# Conceptual Review Agenda

Schedule for 11/30/15 to 11/30/15

# 4450 Denrose Ct Vehicle Major Repair

**Description of project:** This is a request to locate a vehicle major repair shop at 4450 Denrose Ct. (parcel #8715216001). This will be a change of use to vehicle major repair from unlimited indoor recreation with no alterations to the existing building. The site is served by 82 parking spaces. The parcel is located in the General Commercial (CG) zone district. This proposal will be subject to a Minor Amendment.

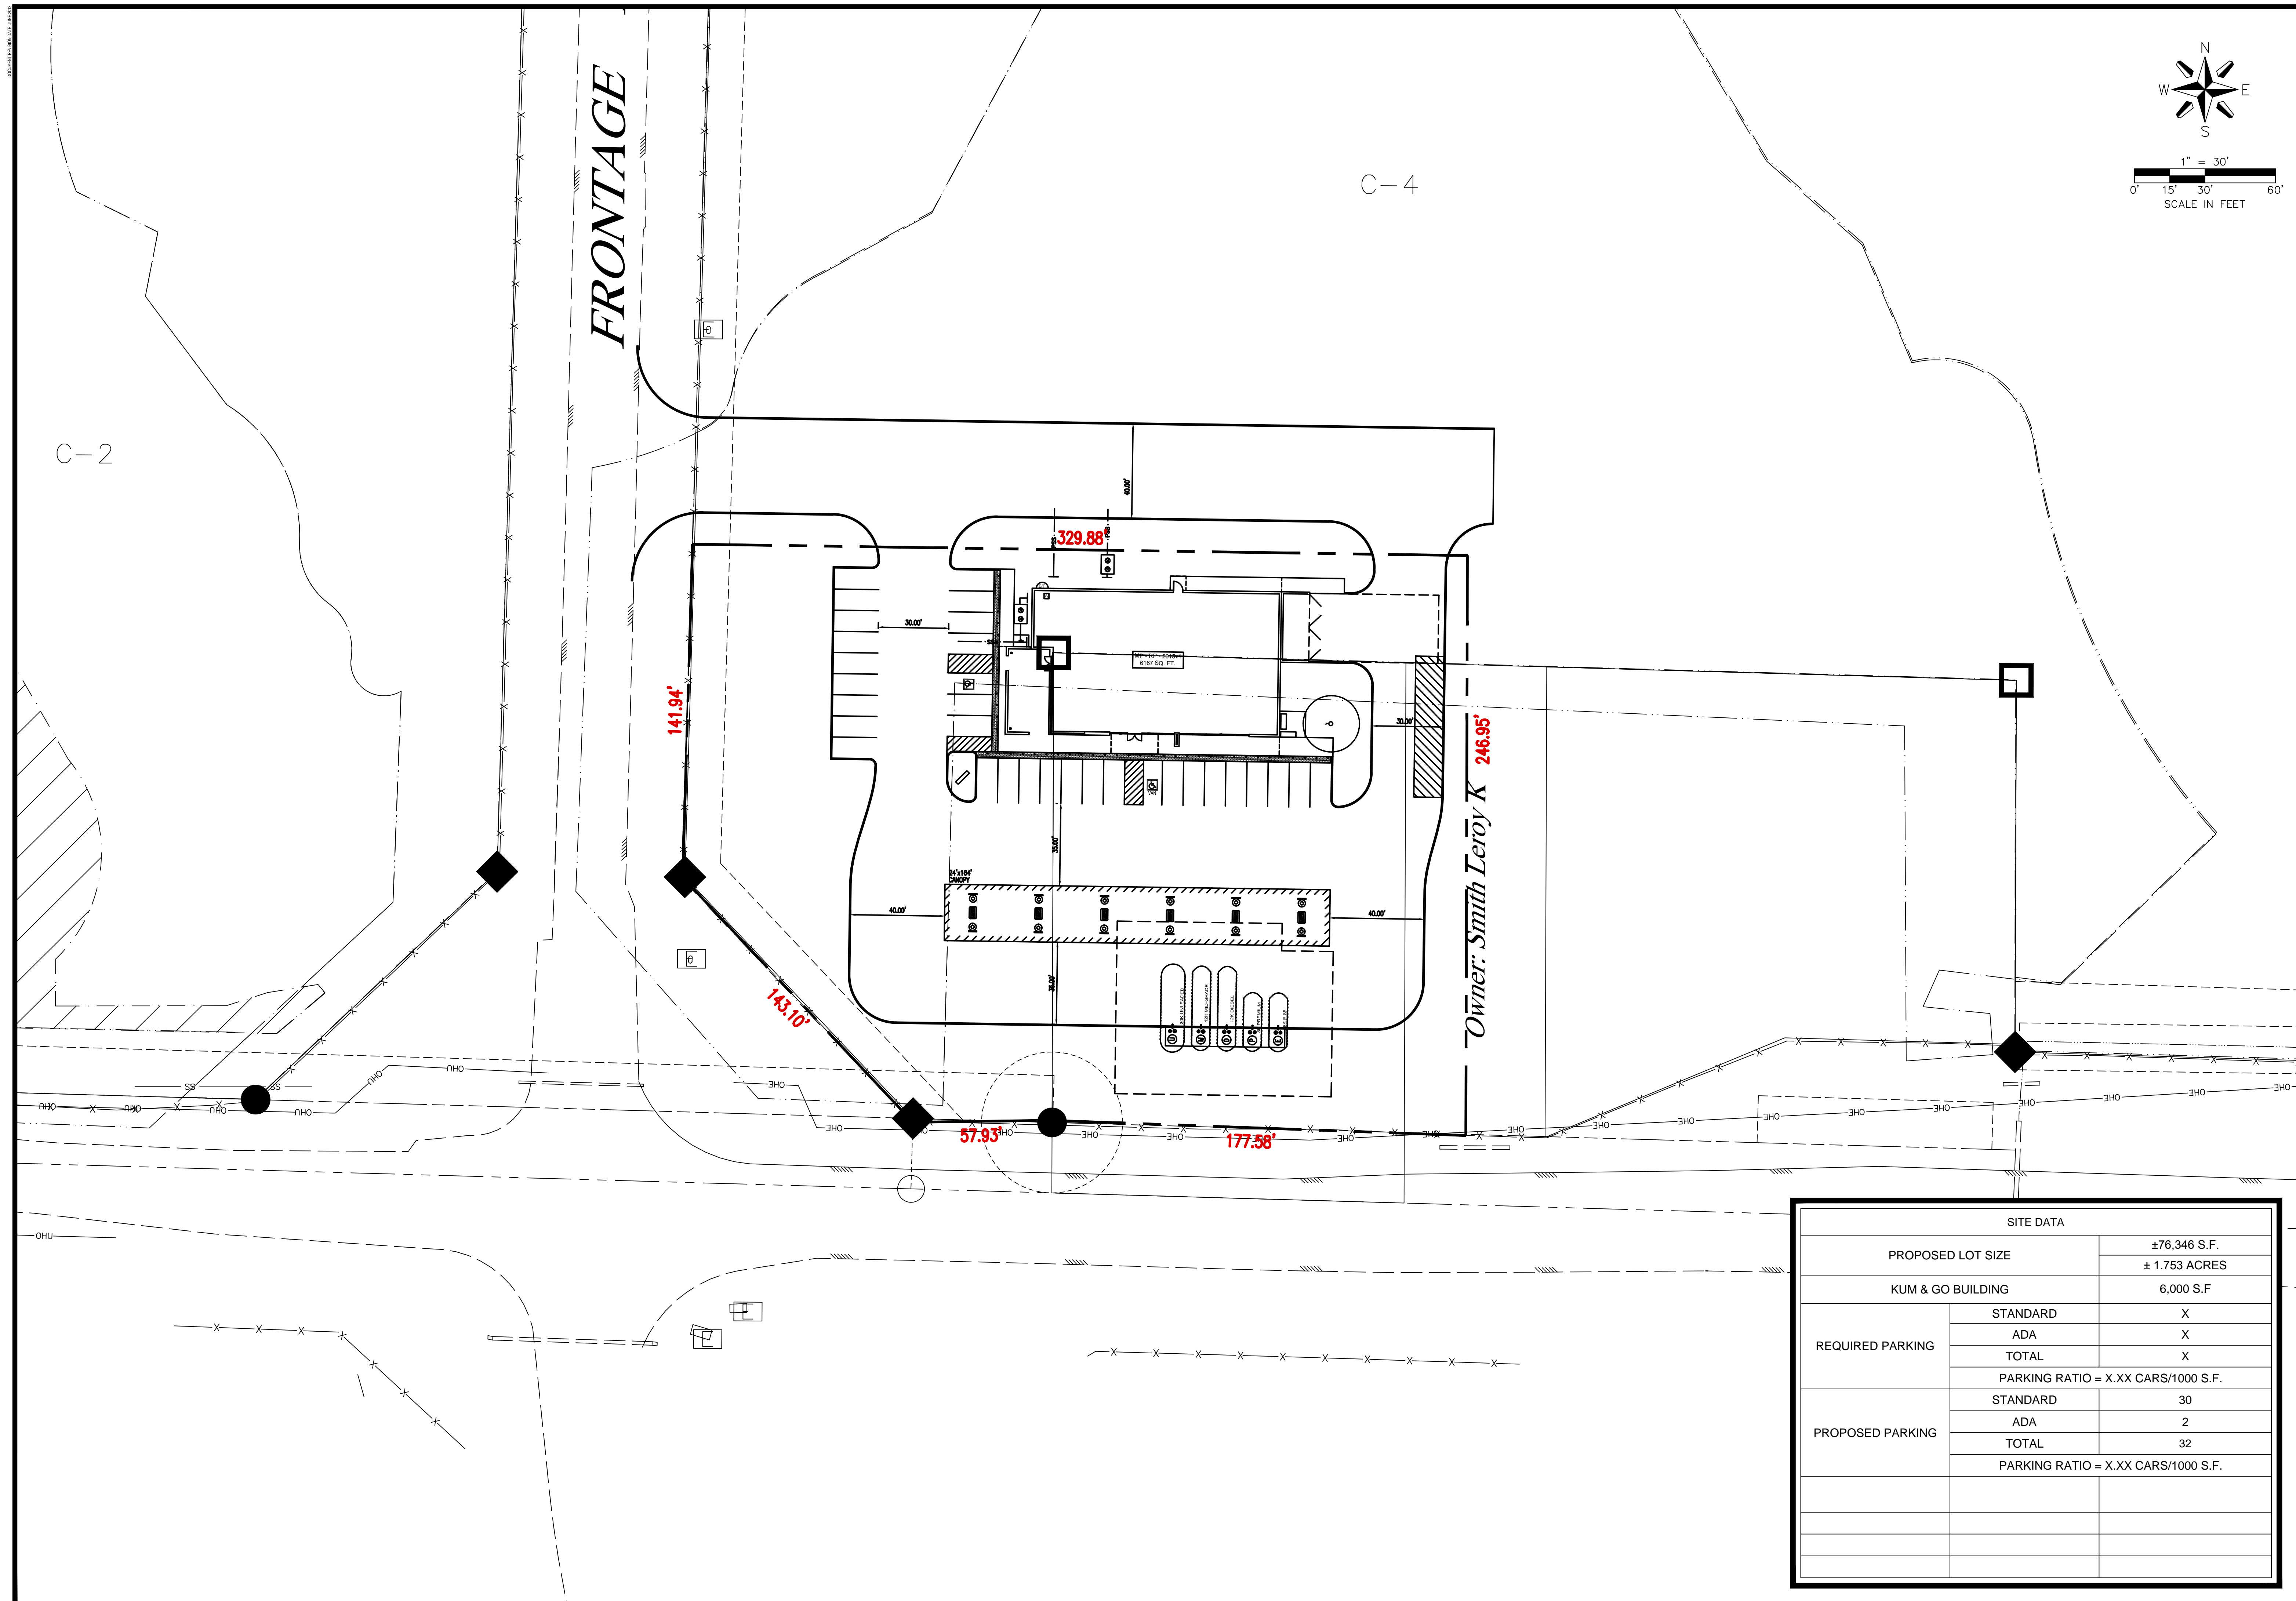
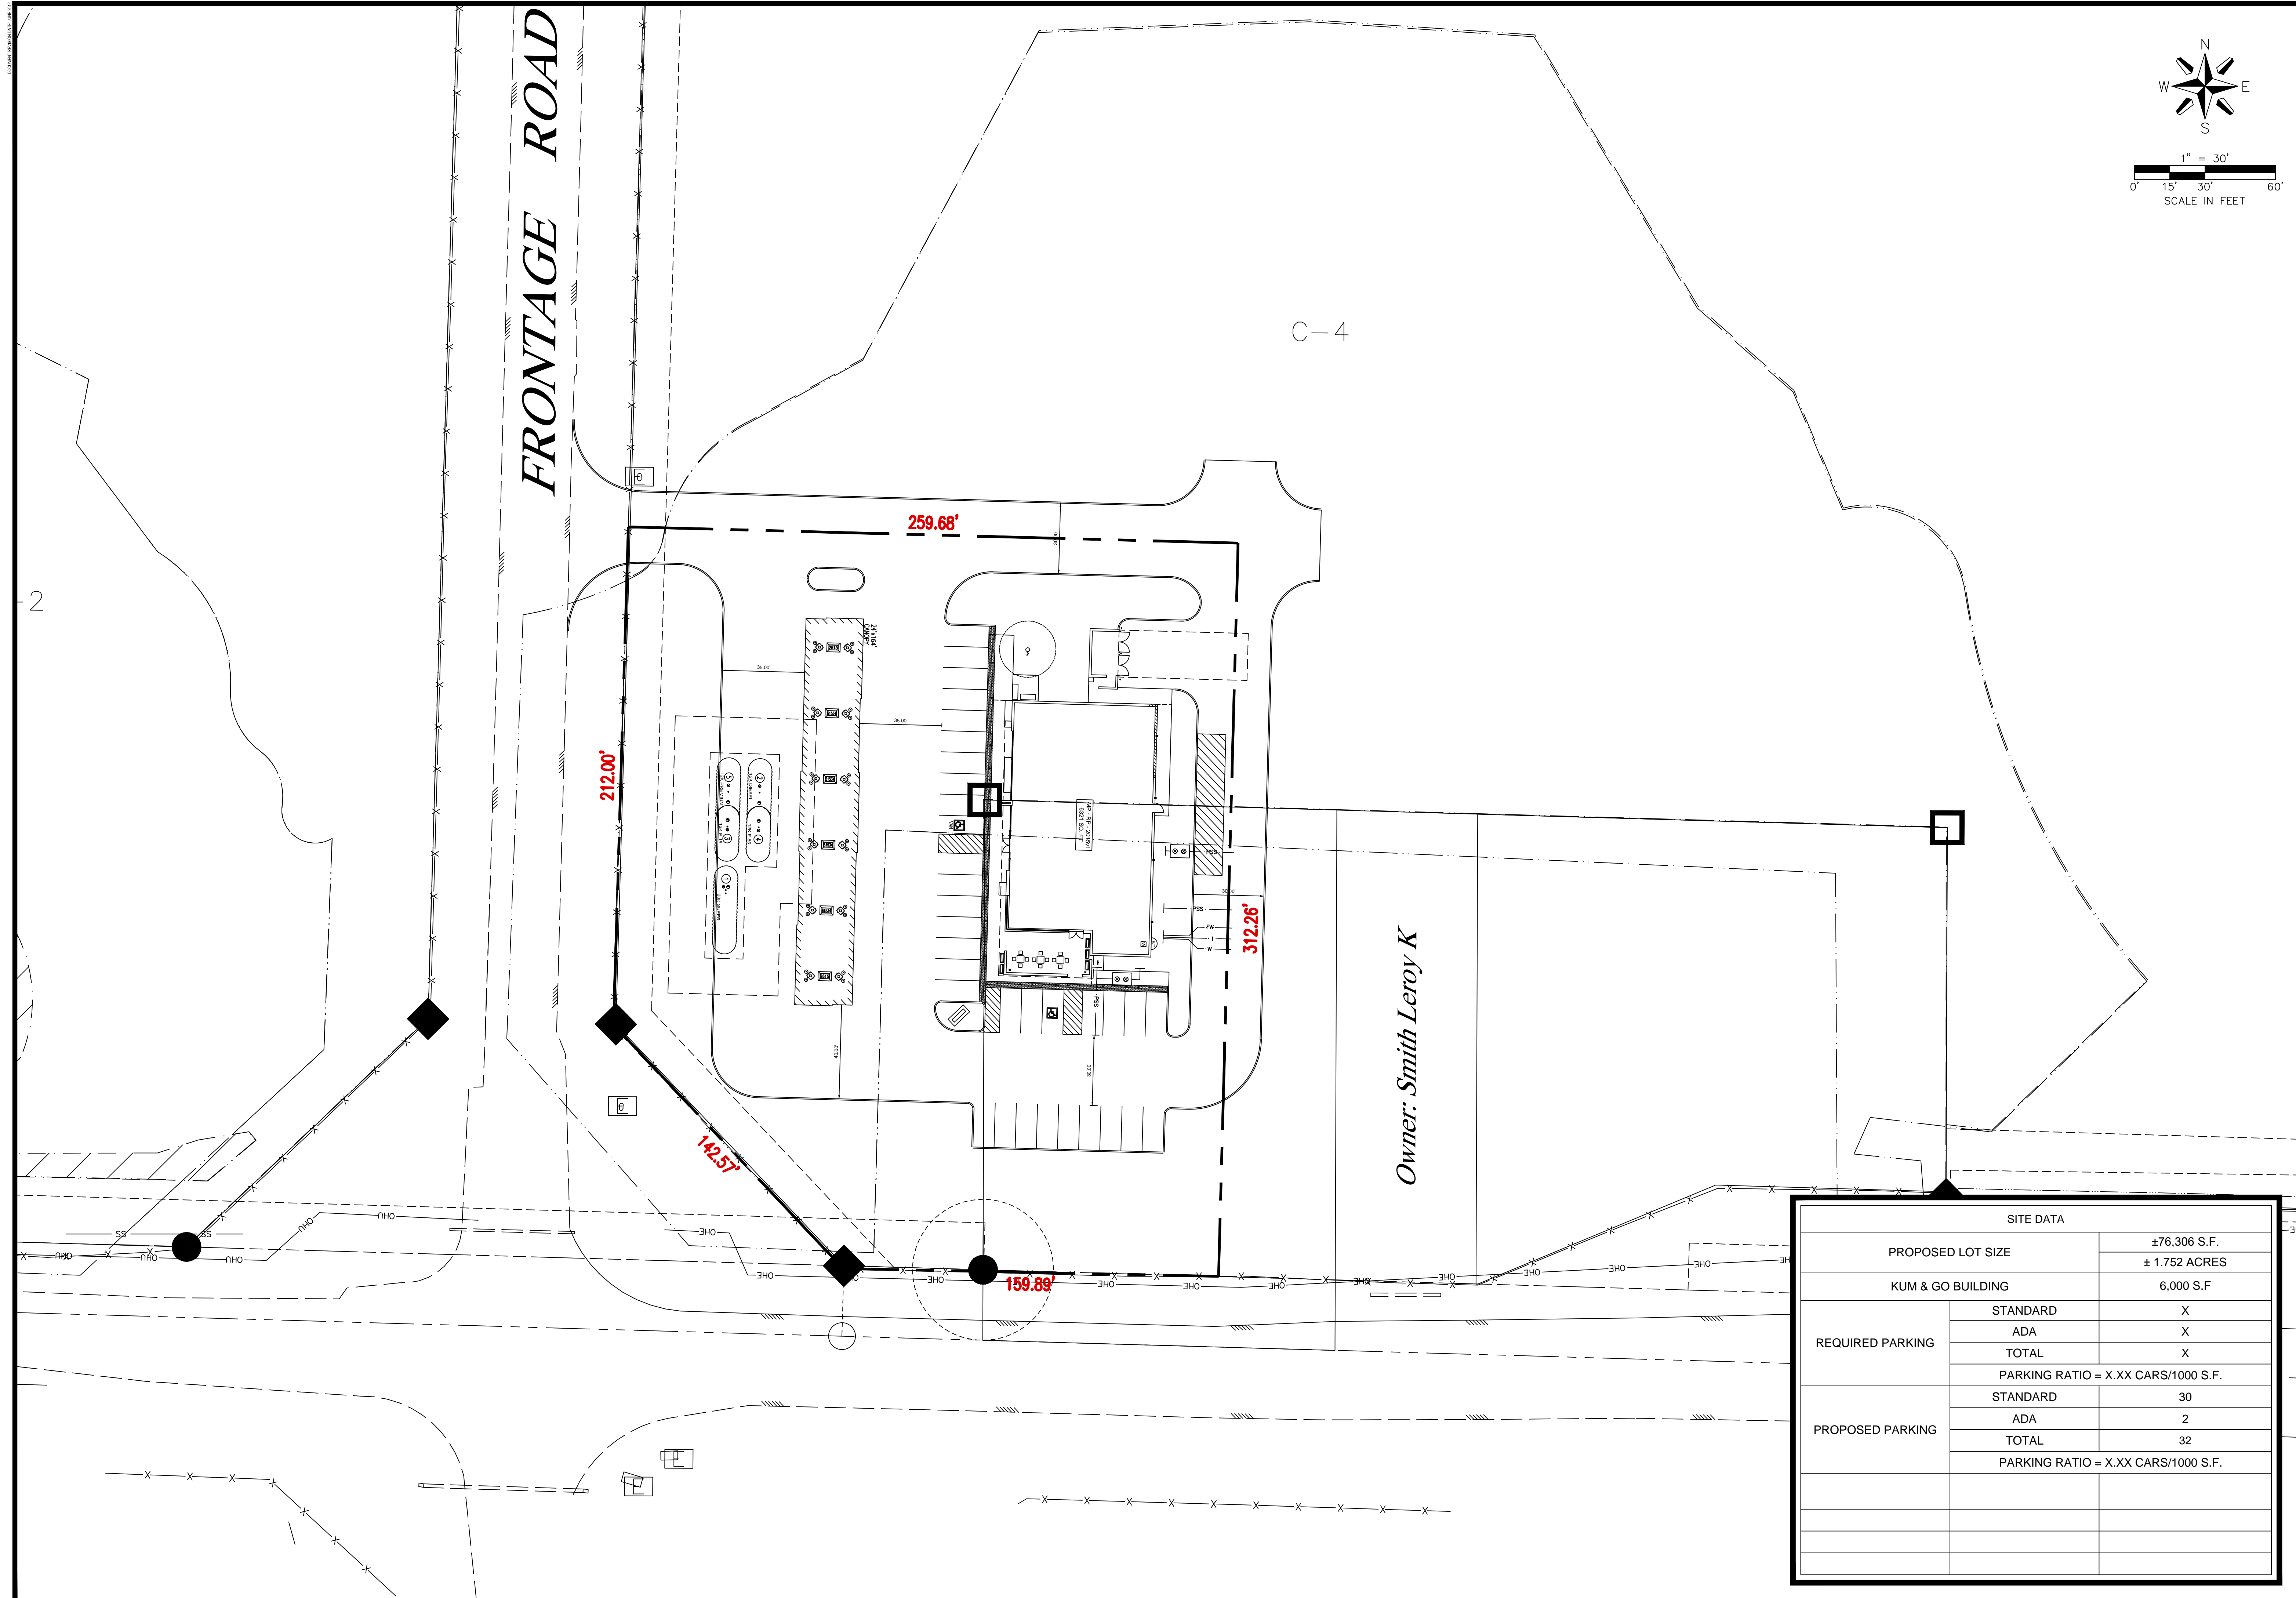
3. The development's access location will need to meet City and CDOT standards for access spacing and should comply with the approved Overall Development Plan. It appears to be too close to Prospect.

9. The proposed access point off of the frontage road does not comply with the approved Overall Development Plan for the site; it is too close to Prospect. The ODP will need to be revised to show any proposed changes to the access.

13. 13 The proposed site plan appears to leave a significant portion of the site devoted to landscaping and stormwater detention and water quality. The applicant is encouraged to consider providing opportunities to serve the traveling public by adding an outdoor dining area, patio, picnic shelter, dog exercise area, playground or other features that would serve the traveling public and make better utilization of the available land area.
